KINCH SUBDIVISION

Construction Drawings

PCD FILING NO. MS-204

ENGINEERING RECORD DRAWINGS

GRADING & EROSION
CONTROL PLAN

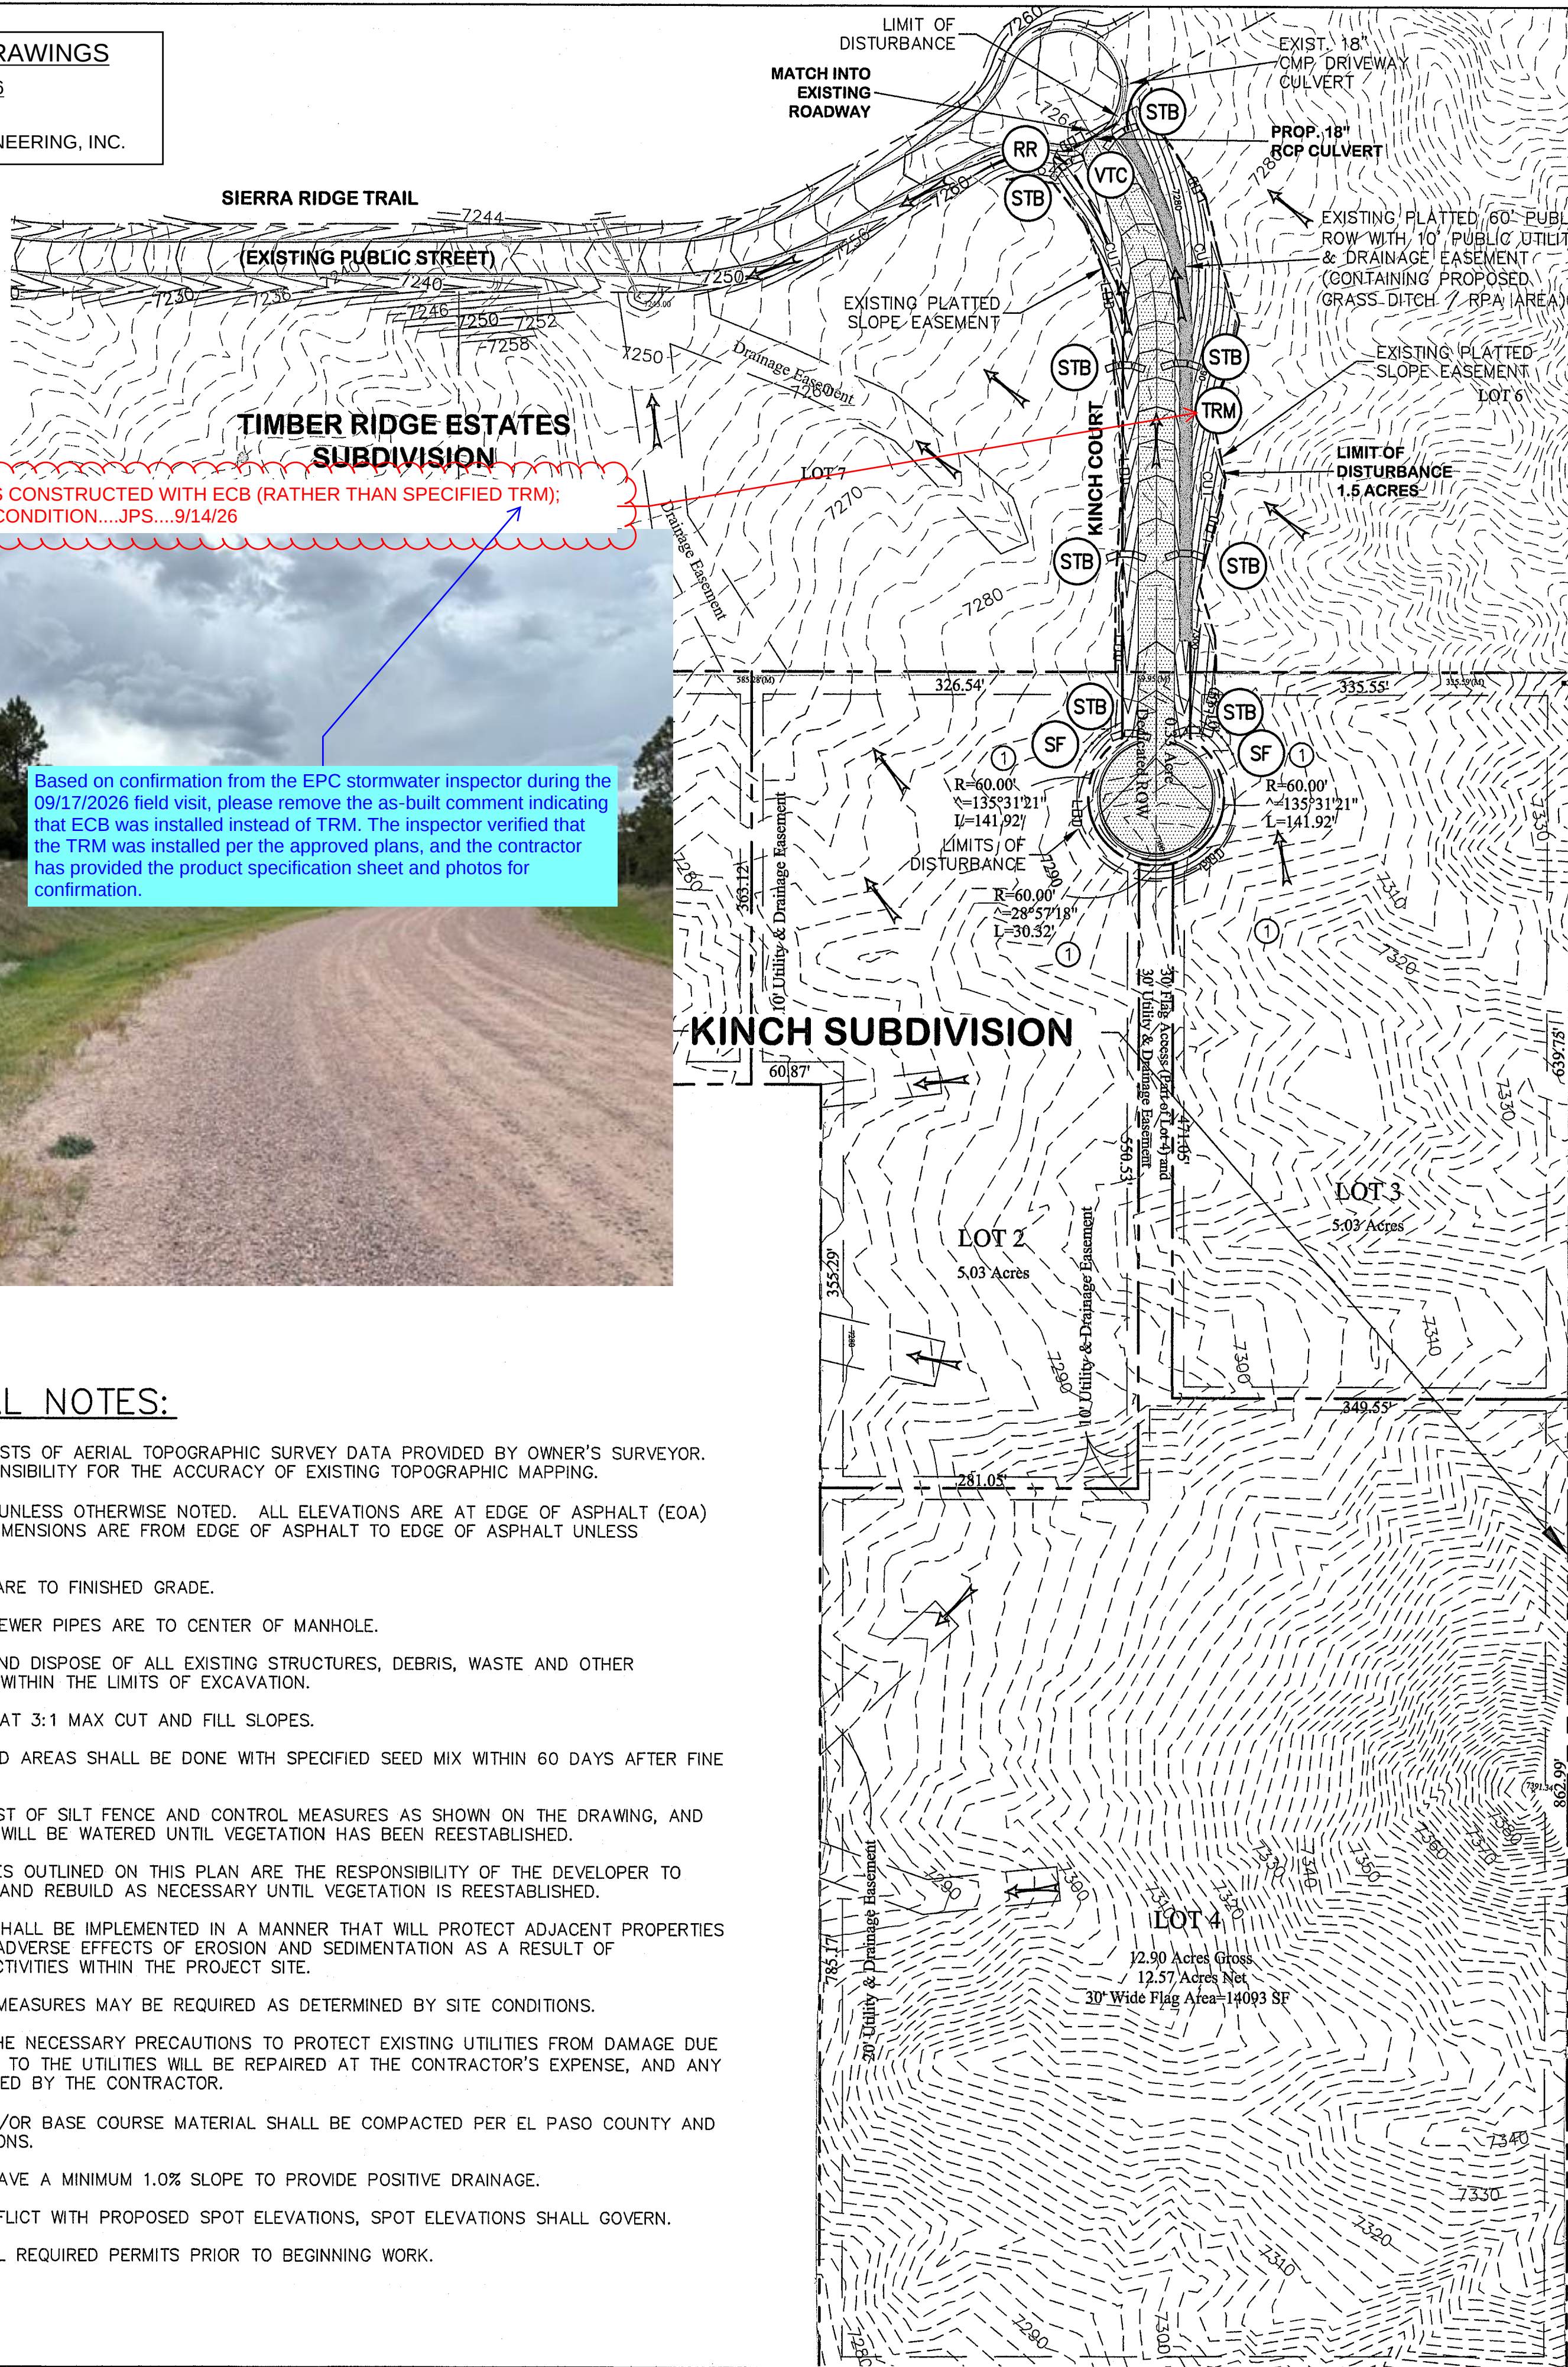
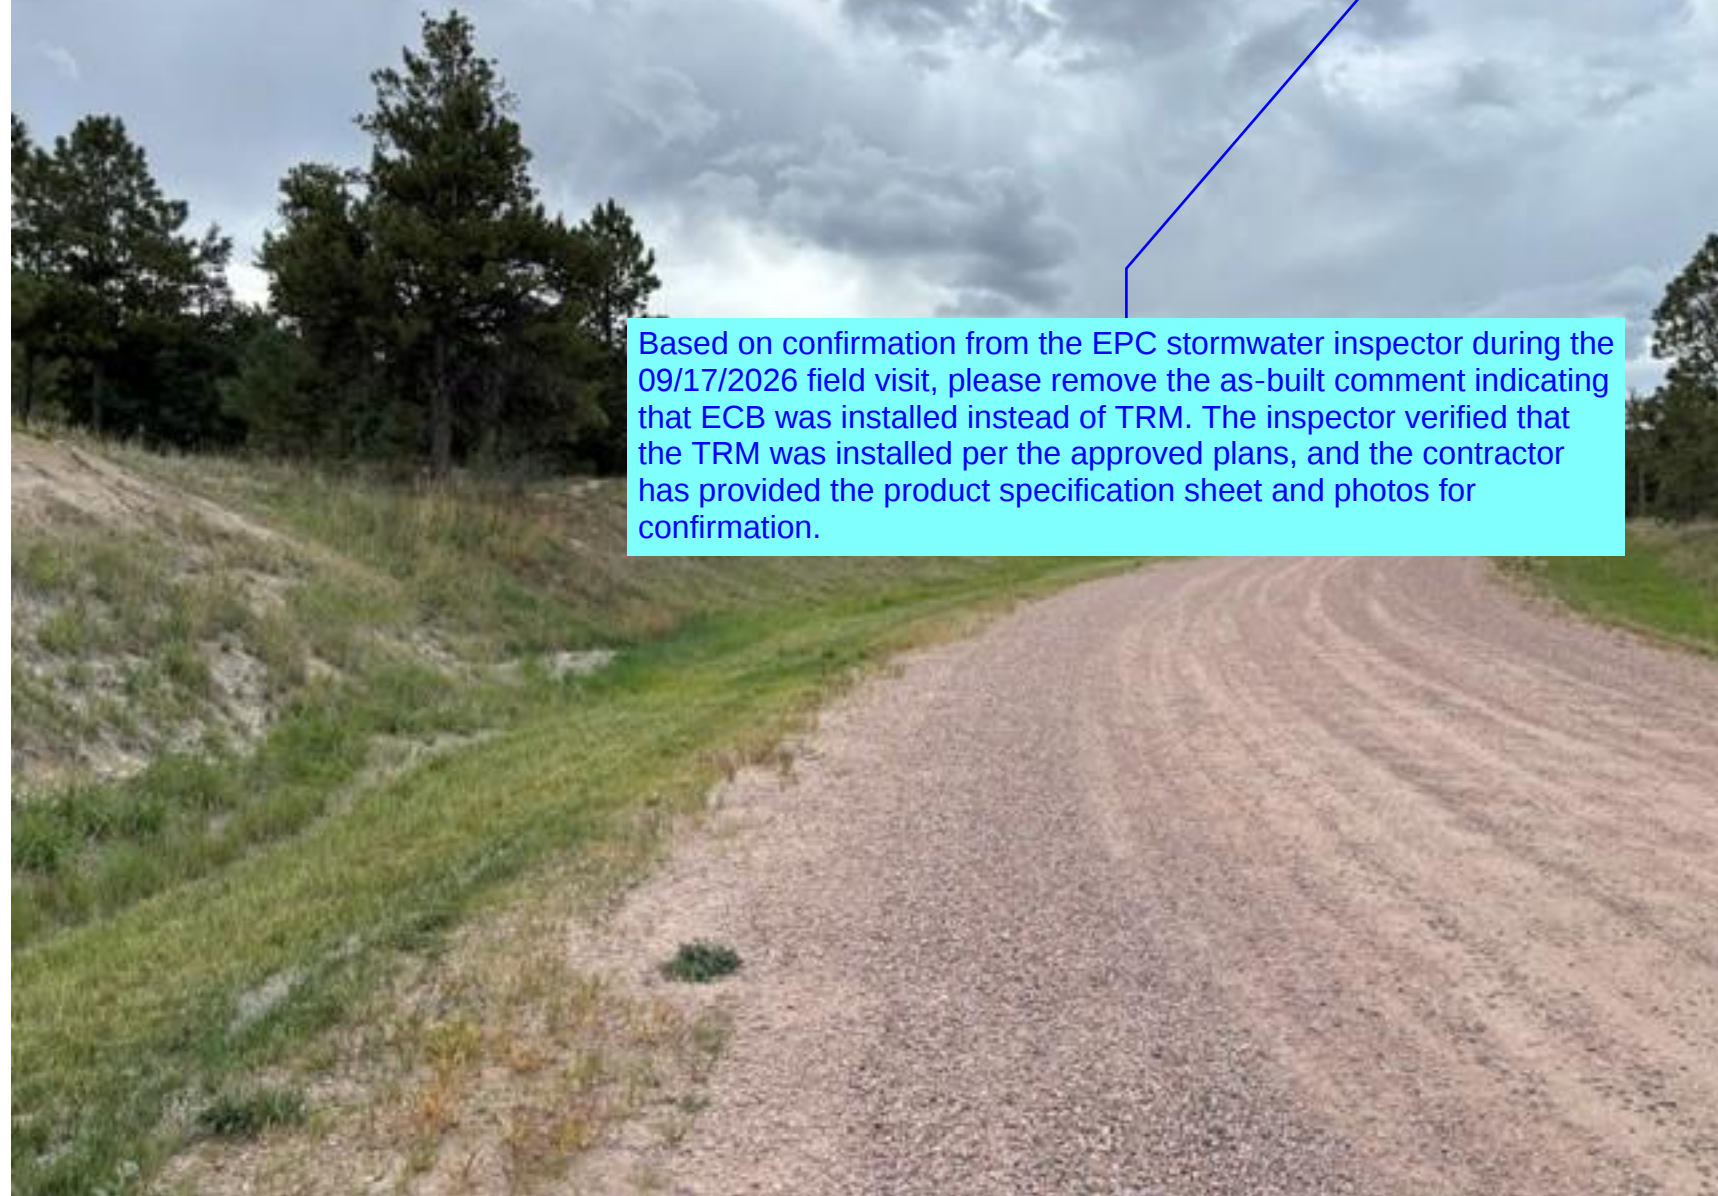
AS-BUILT NOTE: DITCH LINING WAS CONSTRUCTED WITH ECB (RATHER THAN SPECIFIED TRM); GRASS-LINED DITCH IS IN STABLE CONDITION.....JPS...9/14/26

Based on confirmation from the EPC stormwater inspector during the 09/17/2026 field visit, please remove the as-built comment indicating that ECB was installed instead of TRM. The inspector verified that the TRM was installed per the approved plans, and the contractor has provided the product specification sheet and photos for confirmation.
